TRAFFIC DIVISION – BUREAU OF TRAFFIC ENGINEERING

U.S. 1 & ENTR. TO UNIV. OF MD/ ROSSBOROGH LN.

SHEET NO. 12 OF 24

DRAWING NO. TS-1096

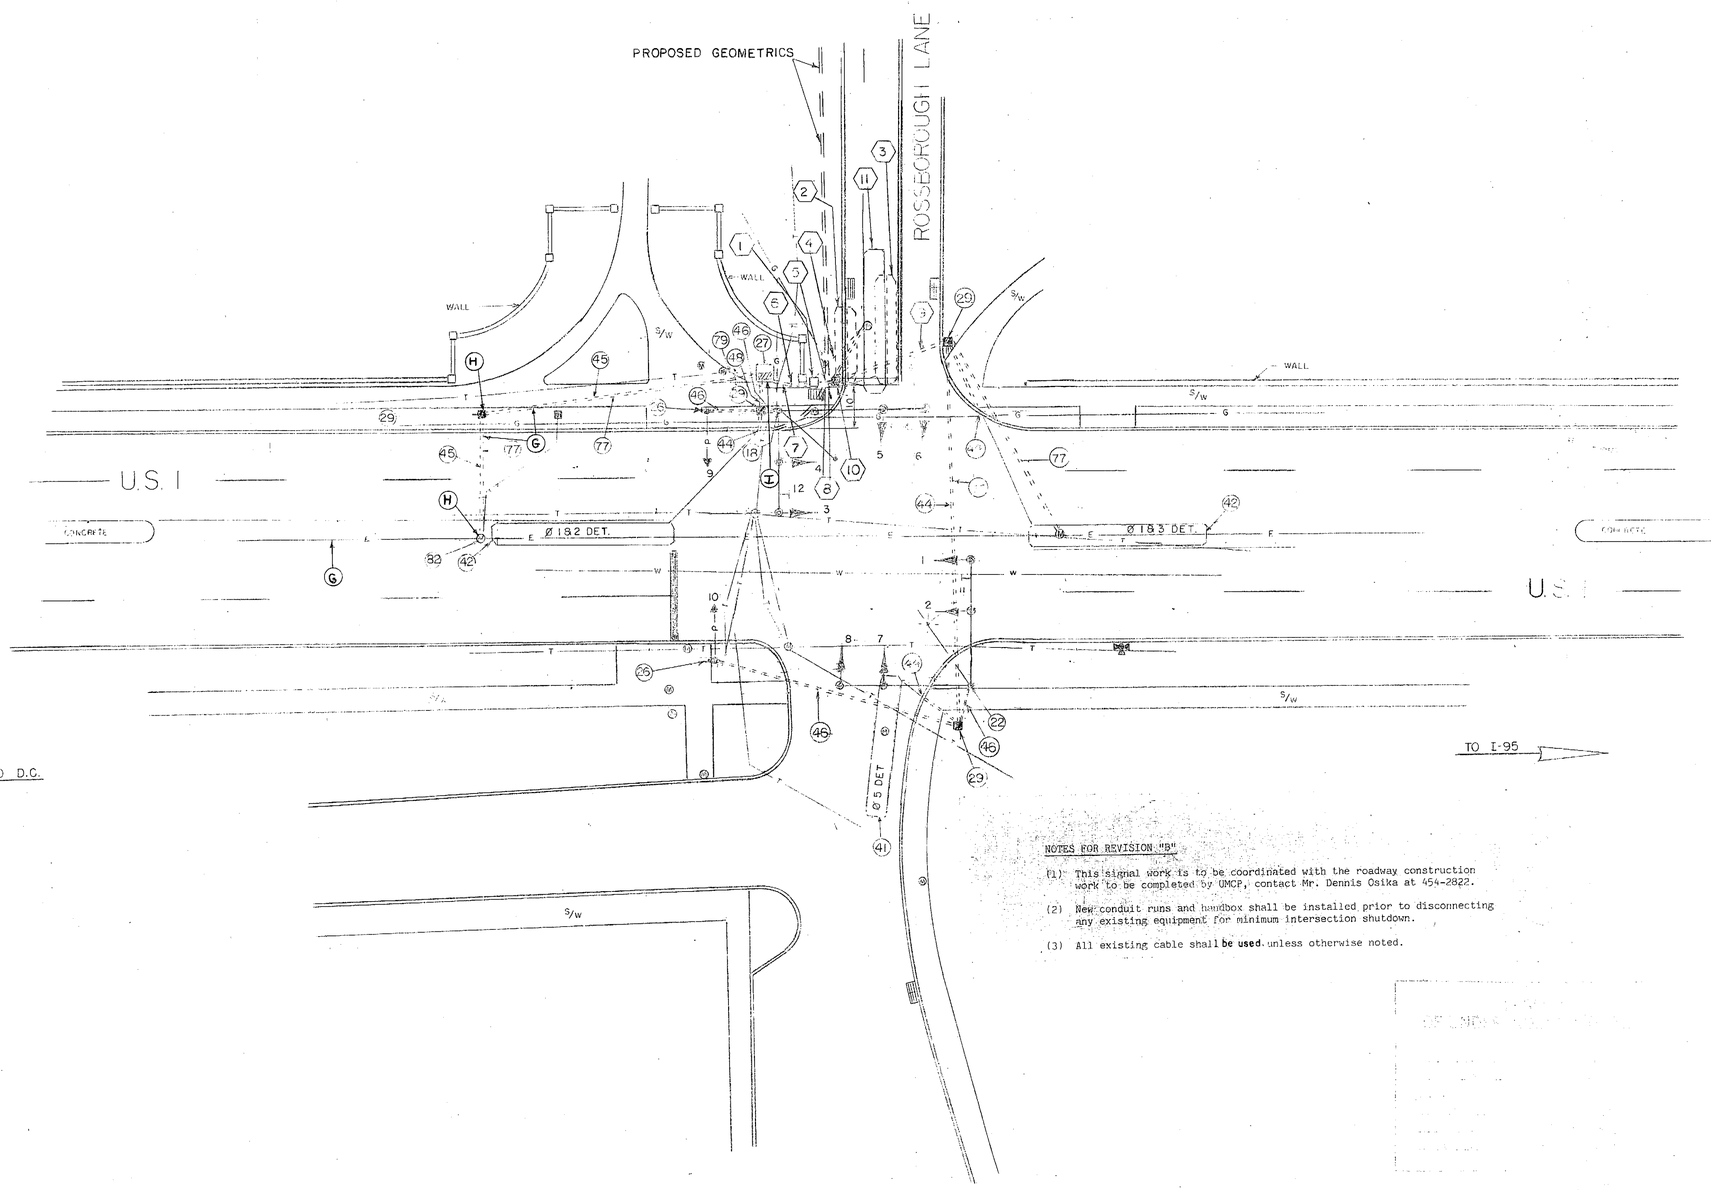
C	REVISE ELECTRICAL SERVICE 4-12-88
RS	
B	10-24-84 RELOCATION OF EQUIPMENT DUE TO NEW GEOMETRICS SHA 855-25003
DCD	
A	10-18-84 "AS BUILT" P 323 004 385 FAP TQF U251-1(7)
DCD

NOTES FOR REVISION "B"

(1) This signal work is to be coordinated with the roadway construction work to be completed by UMCP, contact Mr. Dennis Osika at 454-2822.

(2) New conduit runs and handbox shall be installed prior to disconnecting any existing equipment for minimum intersection shutdown.

(3) All existing cable shall be used unless otherwise noted.
